# PLANNING & ZONING COMMISSION

APRIL 08, 2024, 7:00 PM

Halff Associates, Inc. (Halff) was requested by the City of Sanger to review the final plat and drainage study in support of the engineering plans for the Lakeside Estates located near the intersection of McReynolds Road and FM 455 E. The subject tract is located within the City of Sanger's ETJ. The submittal was prepared by Kirkman Engineering and dated March, 2024. The preliminary plat and drainage comments were found acceptable by Halff in September 2023.

# PLANS FOR THE CONSTRUCTION OF PAVING, GRADING & DRAINAGE IMPROVEMENTS

**MEGAVIEW DRIVE [STA 1+00 - STA 10+00]**

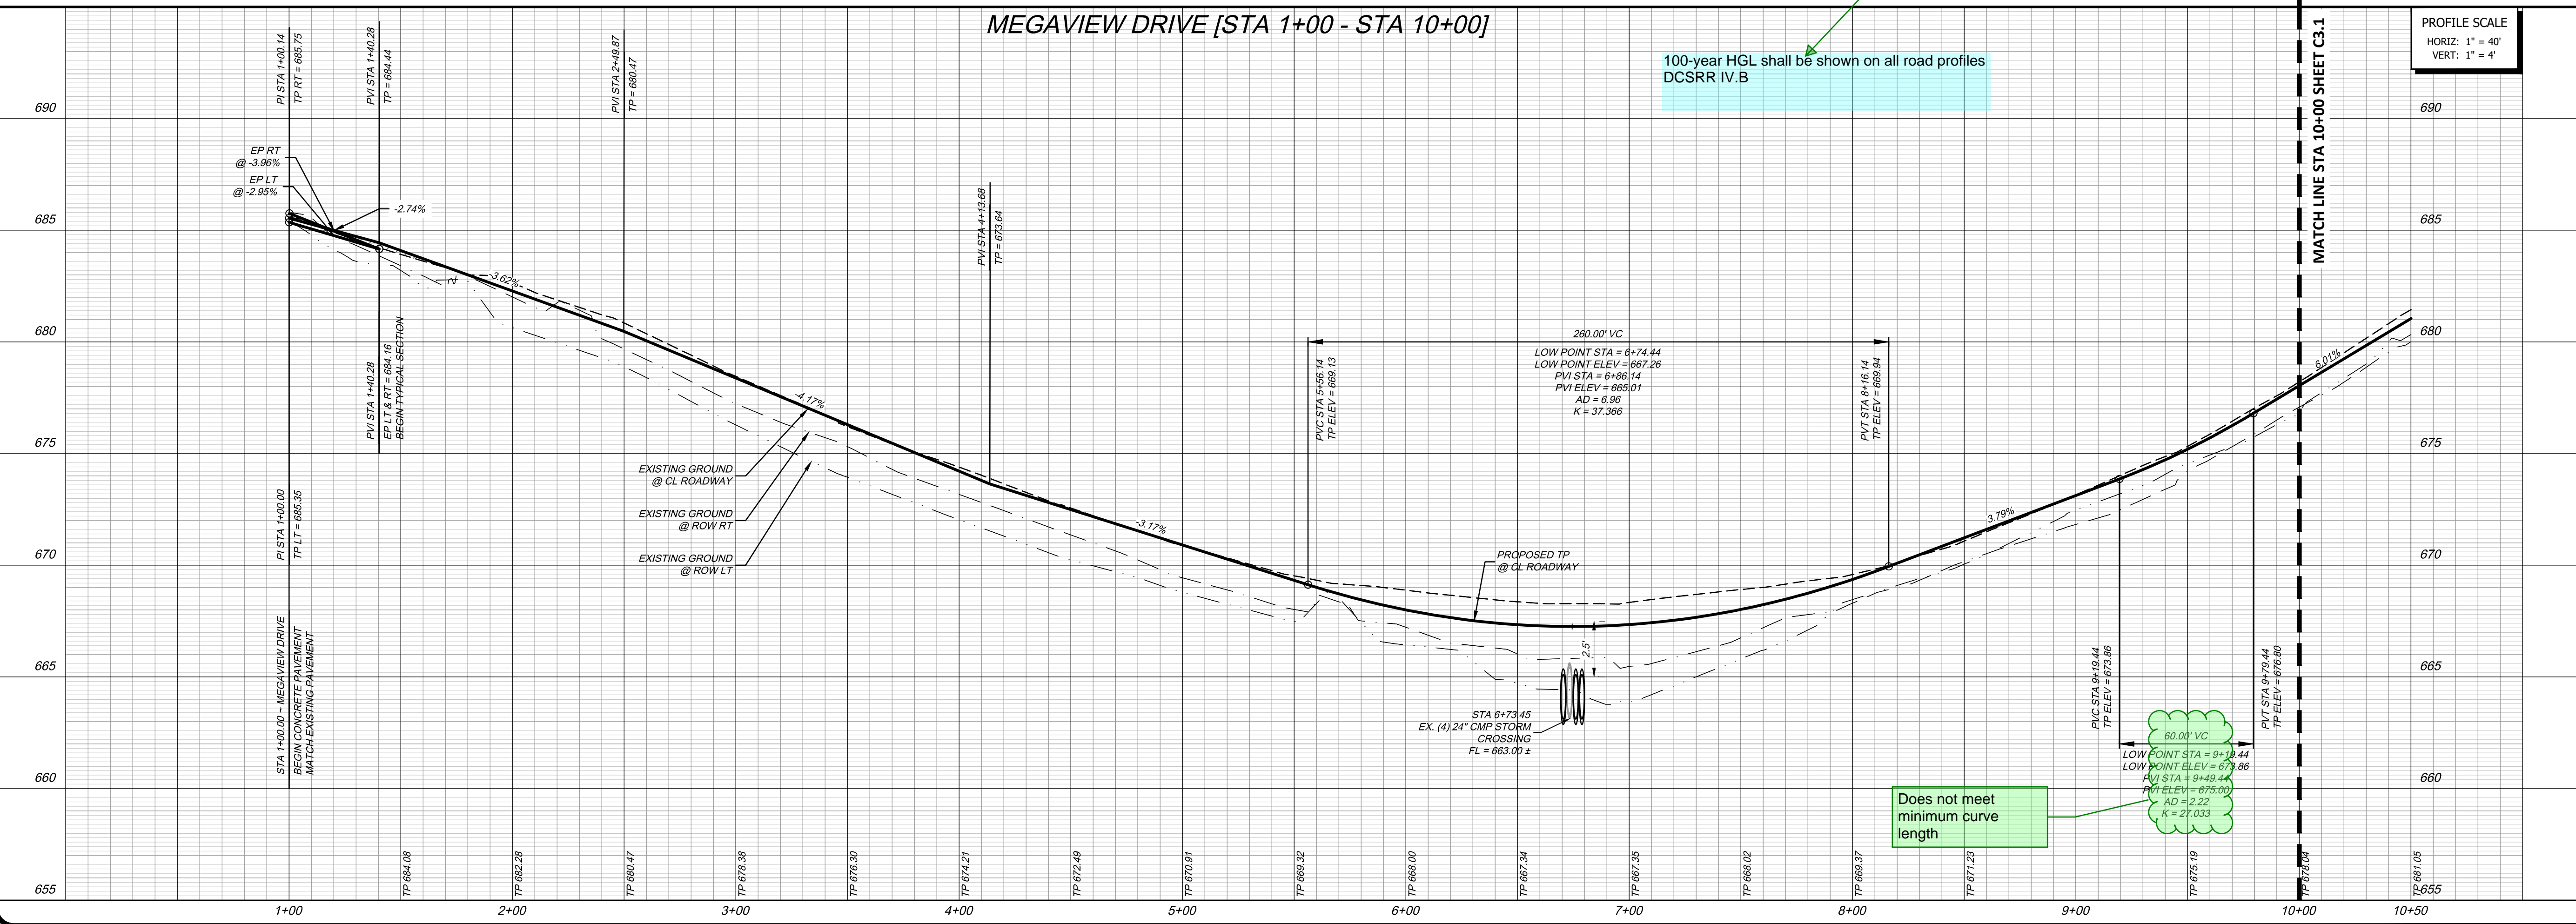
100-year HGL shall be shown on all road profiles DCSRR IV.B

**MEGAVIEW DRIVE [STA 8+50 - STA 16+50]**

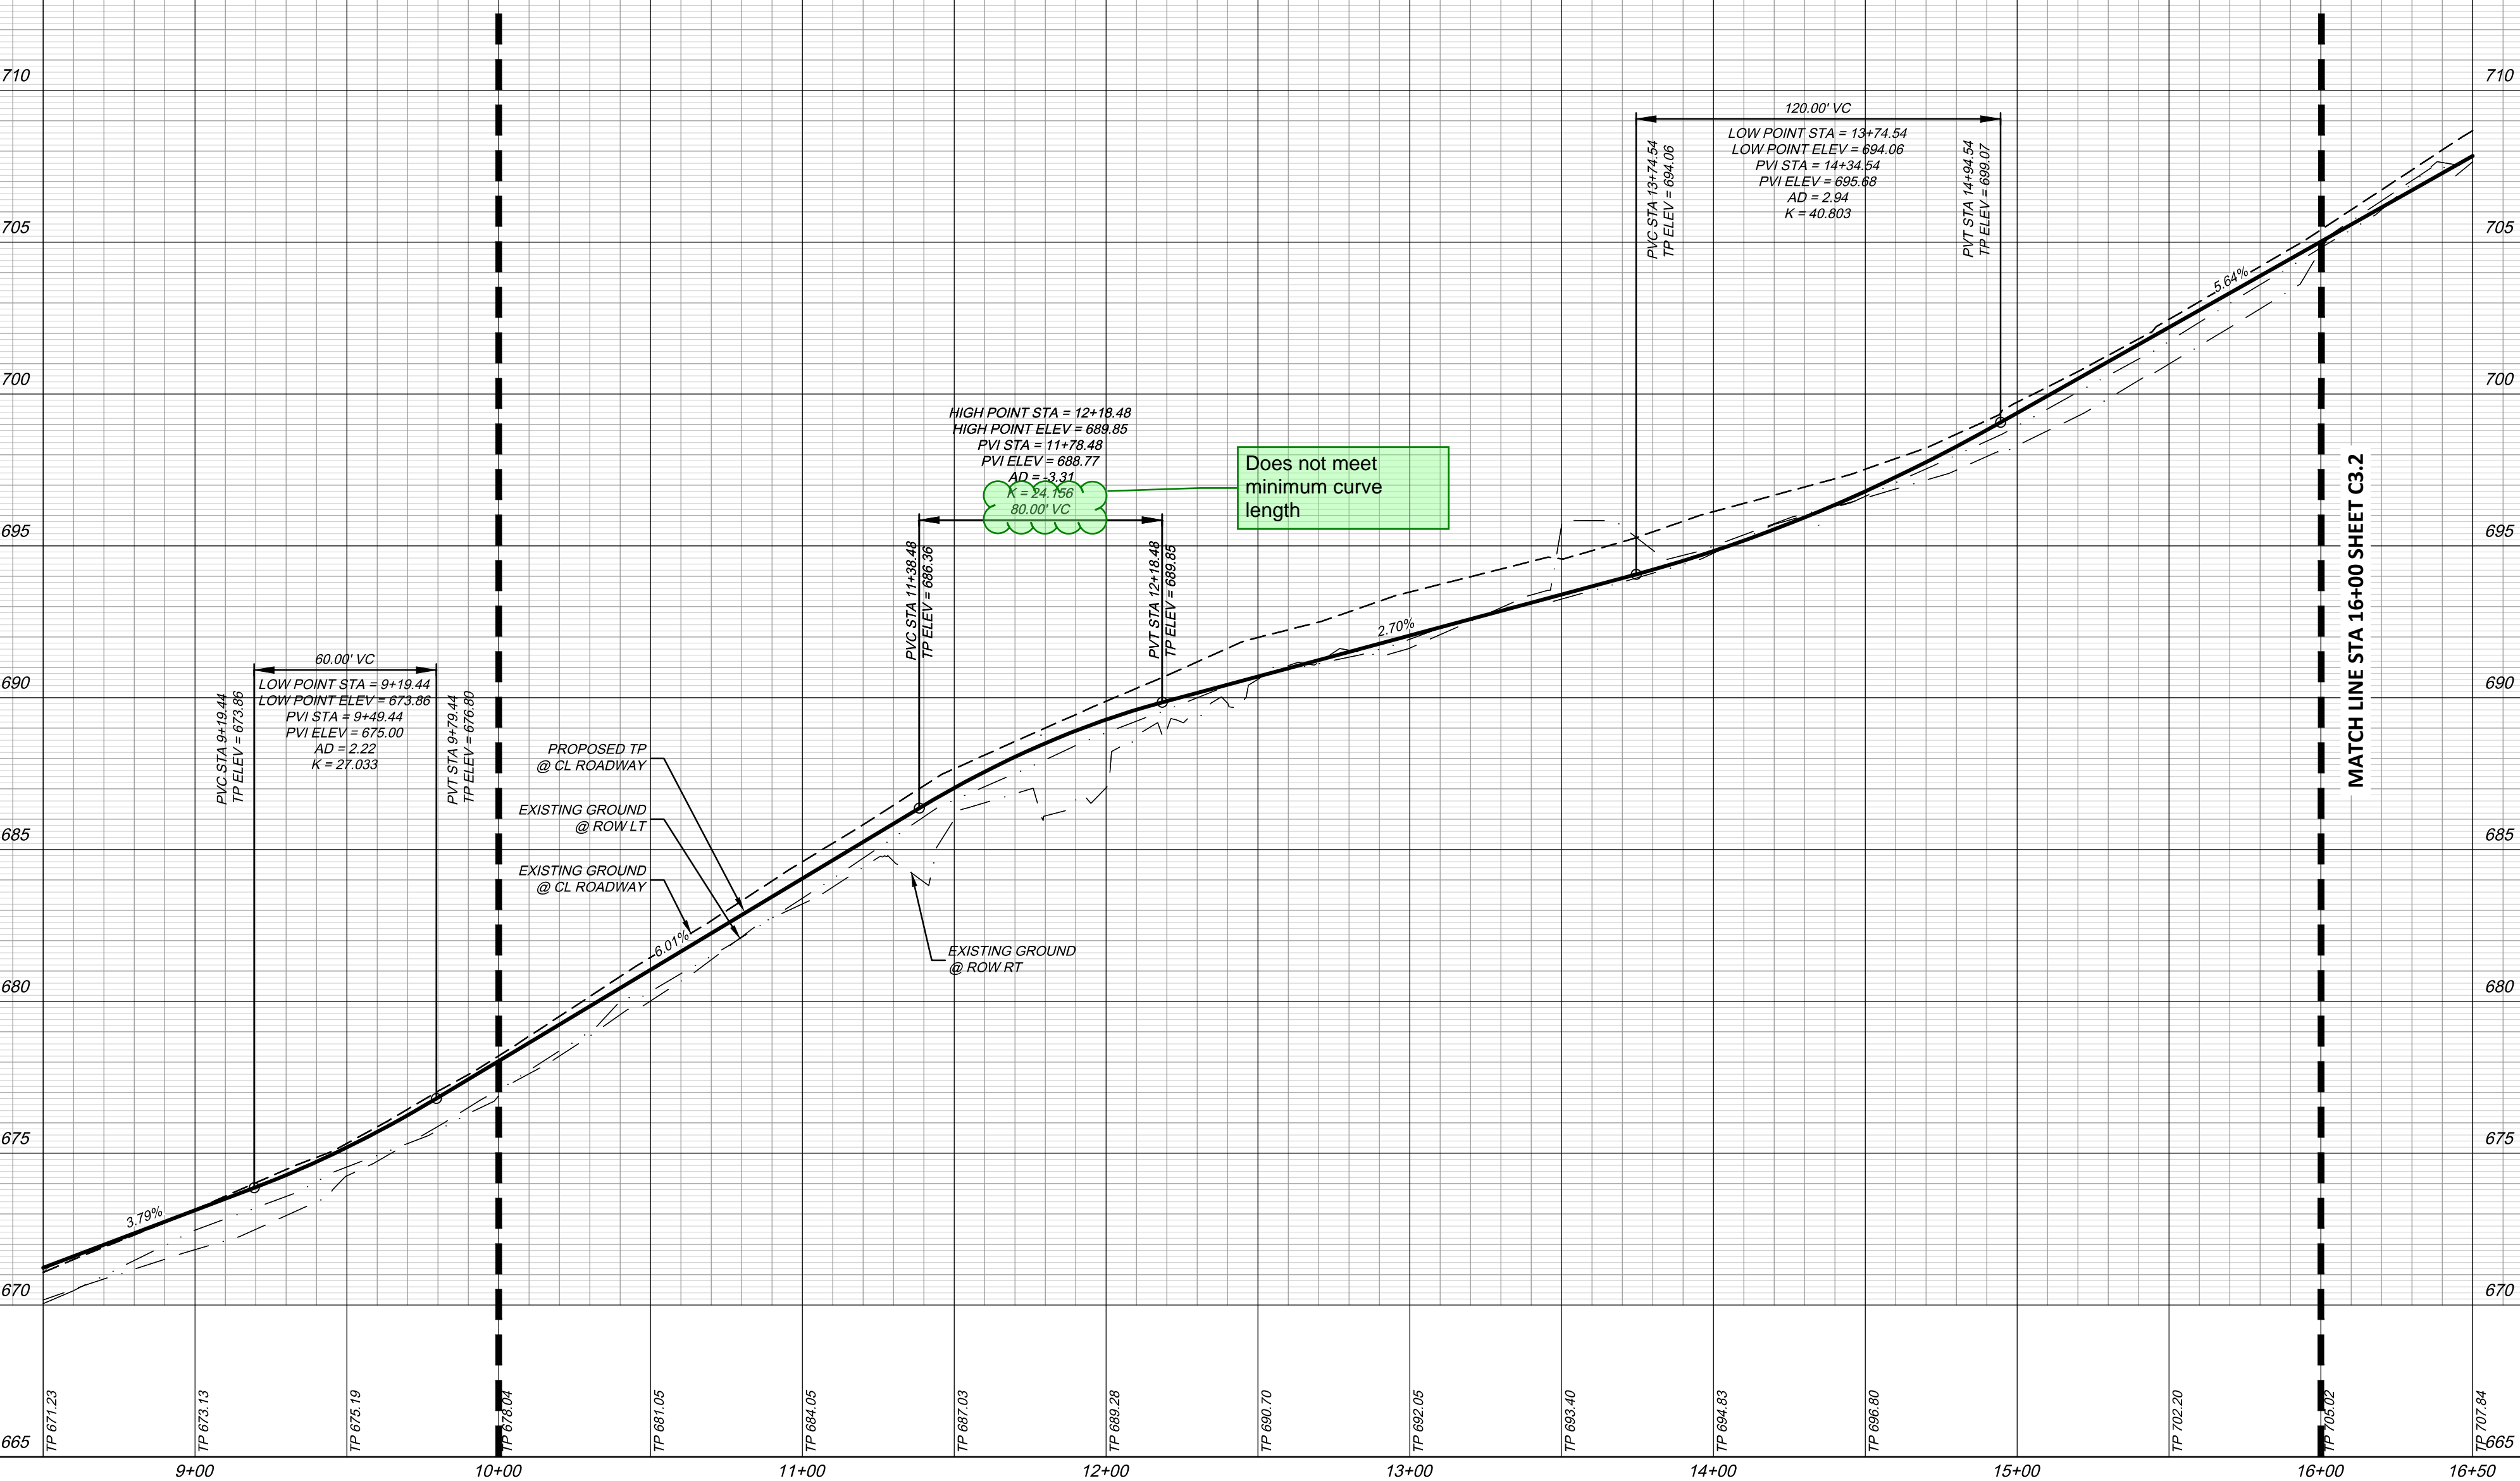
Does not meet minimum curve length

**MEGAVIEW DRIVE [STA 14+50 - STA 22+00]**

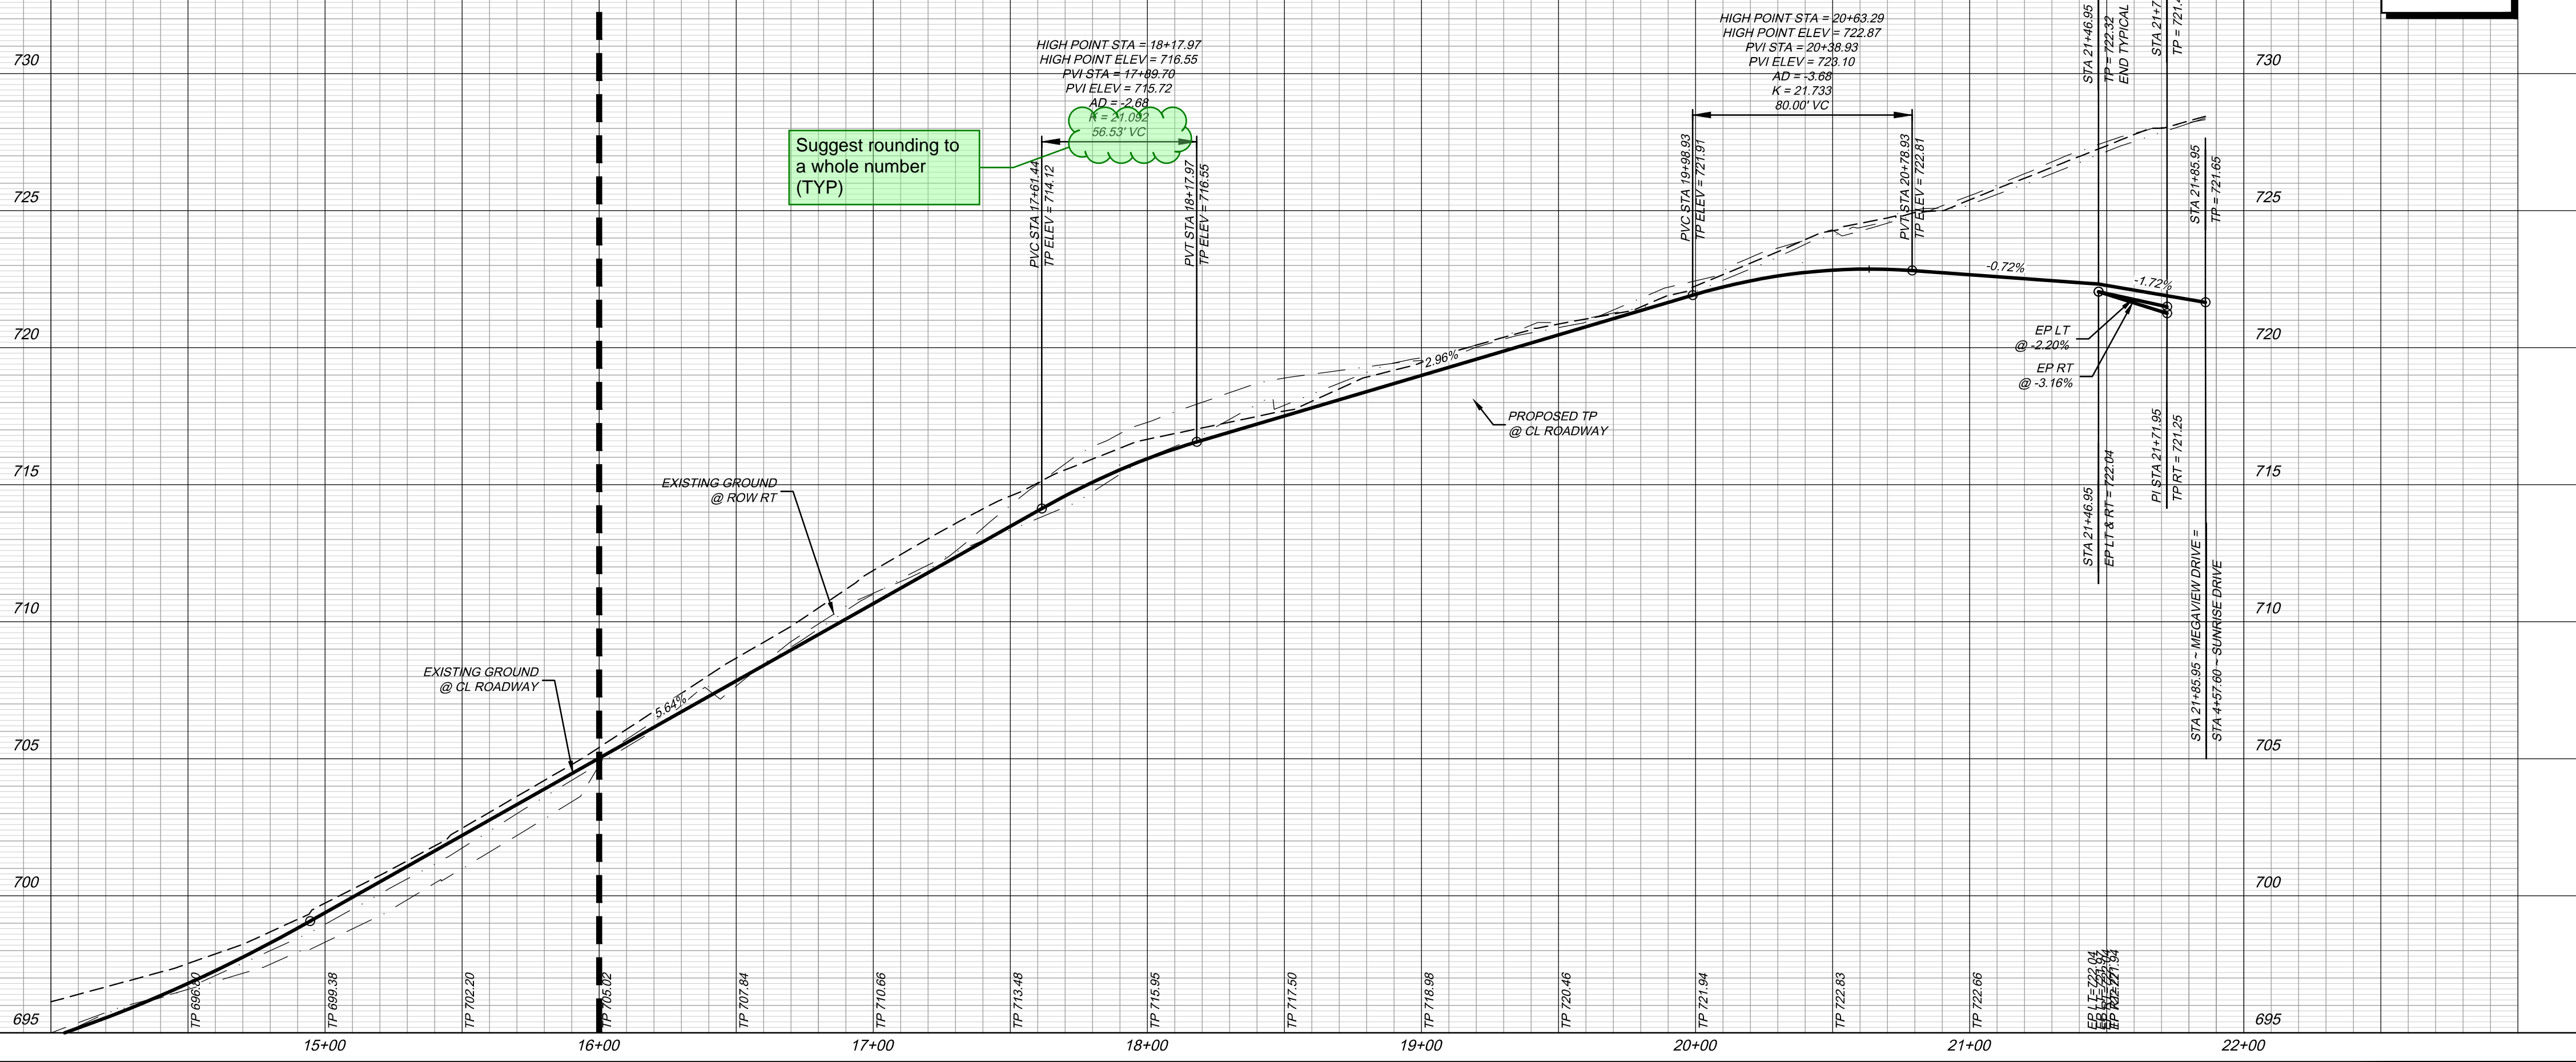
Suggest rounding to a whole number (TYP)

SUNRISE DRIVE [STA 1+00 - STA 7+00]

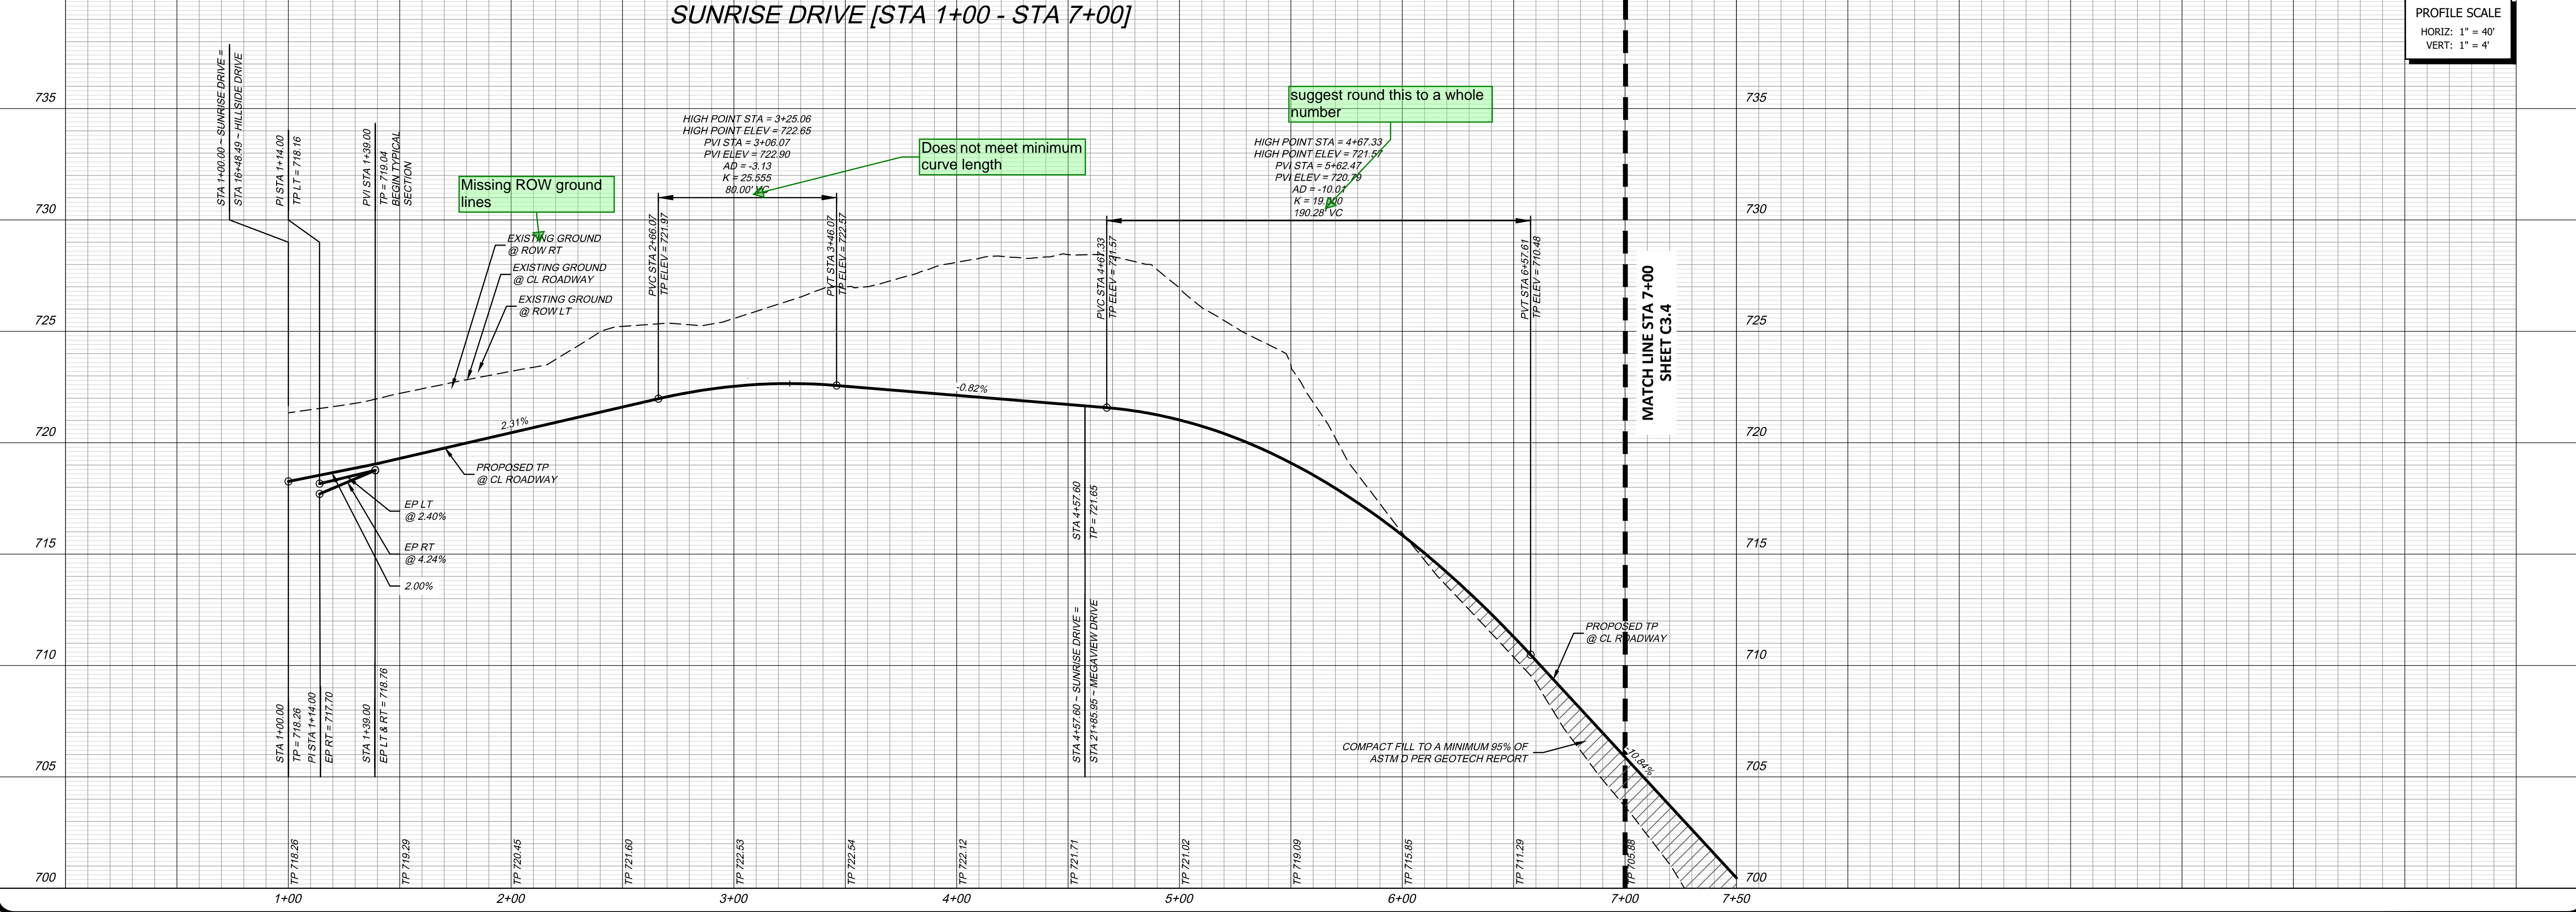
Missing ROW ground lines
